Consent No.
DA No. 10064
Project Title
Black Bear
Project Address
30 Diggings Terrace, Thredbo,
NSW 2625
Project Year
2021

Drawing Title
Cover Page
Drawing No.
A - 0010
Drawing Scale
Revision
N

BLACK BEAR

Drawing Title
Level 0 - GA Plan
Drawing No.
A - 1000
Drawing Scale
1 : 50

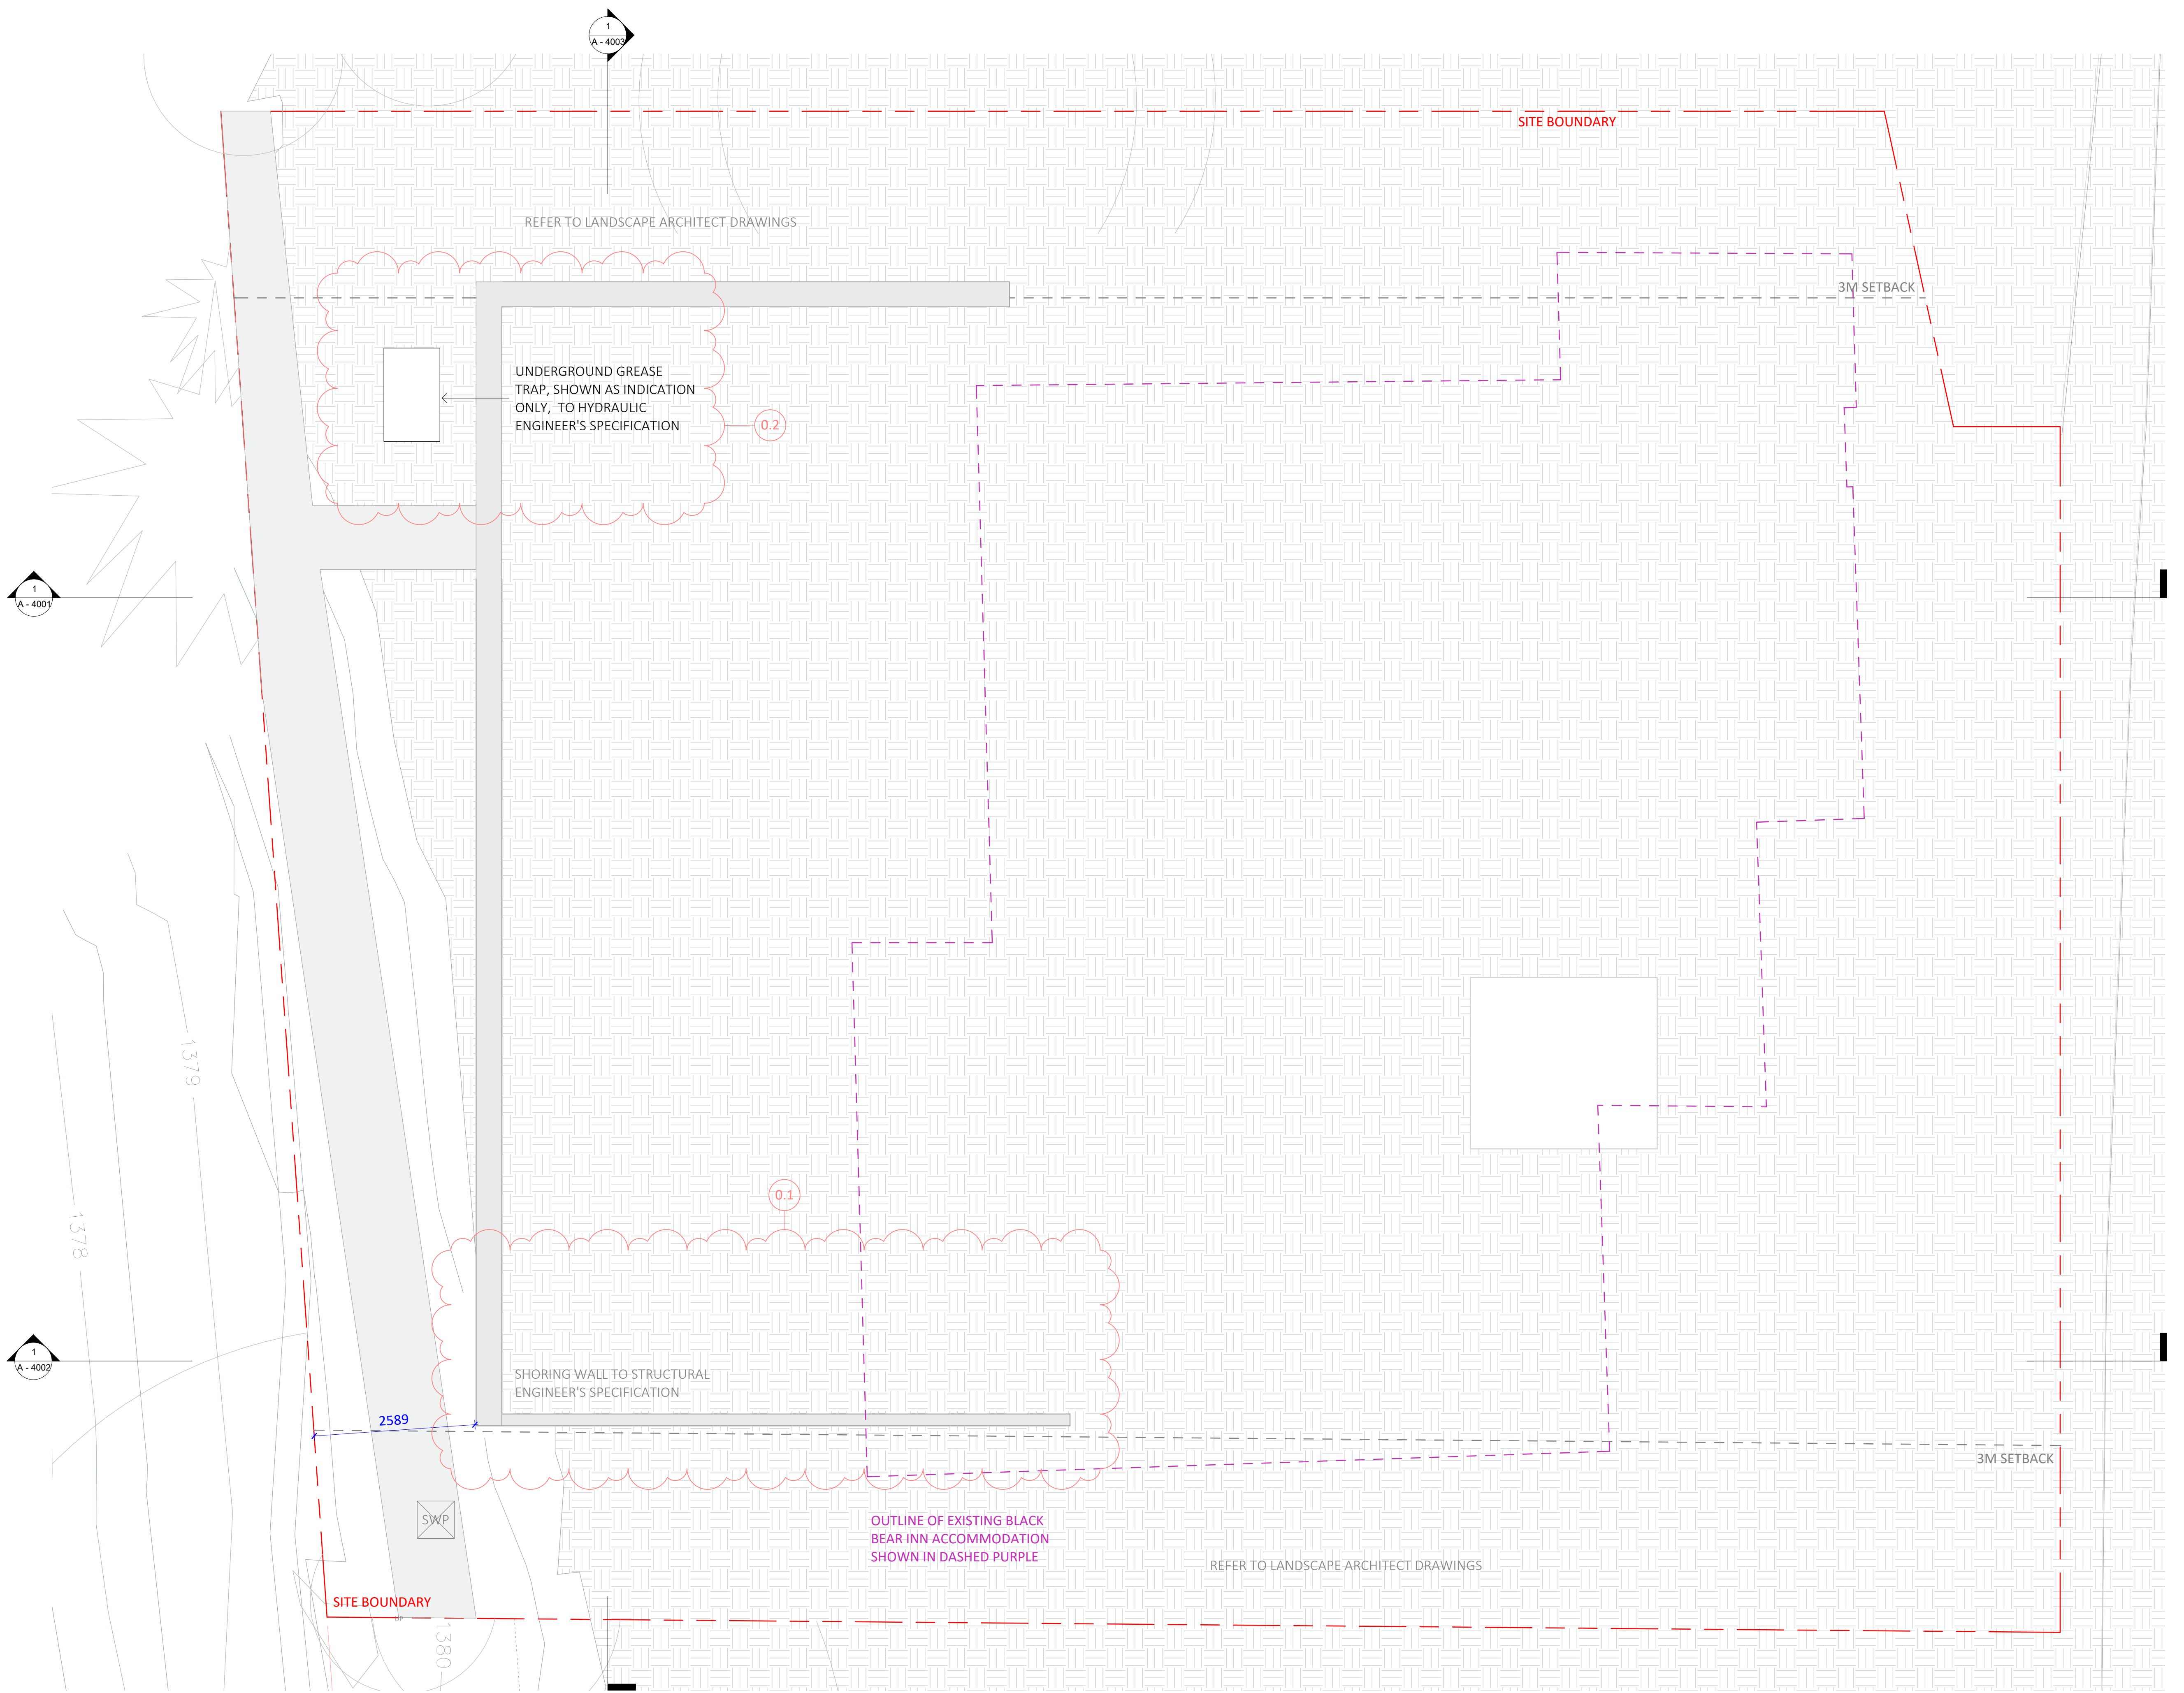
DELETION OF LEVEL 0
BASEMENT
